RE: BR/145/26/HH

Highcroft Cres 51 - TP App - Rev B.pdf;

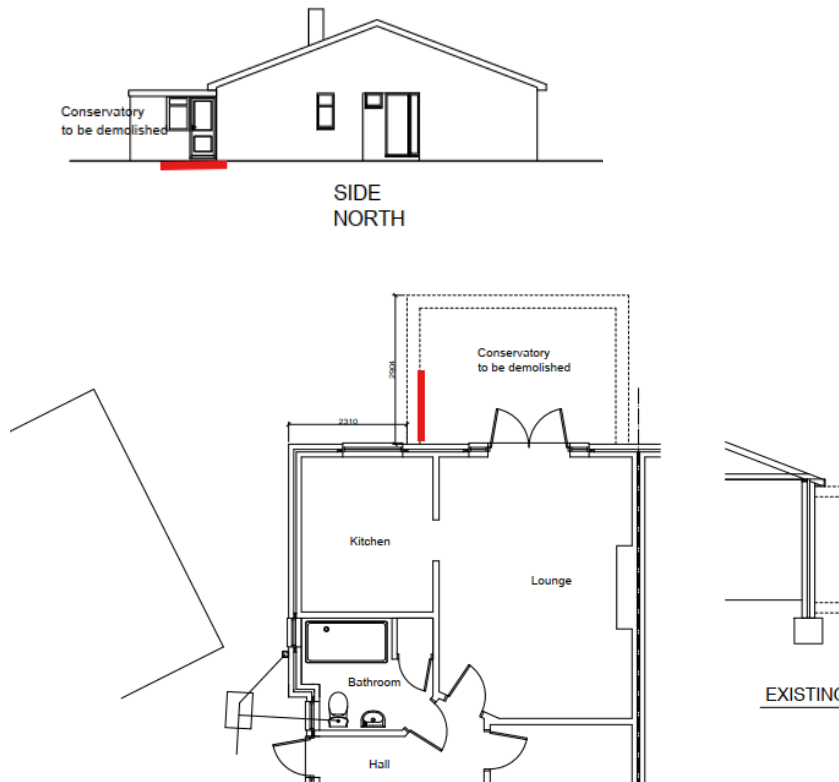
Thank you for the additional information, the only thing holding back this application being validated now is the fenestrations of the conservatory need to be drawn on the existing floor plan, below are the relative images.

You already have the existing elevations of the conservatory, they are in the attached, so as not to cause you more confusion I've change the existing plan in this file for the latest one I sent you yesterday

As it being demolished why does it matter
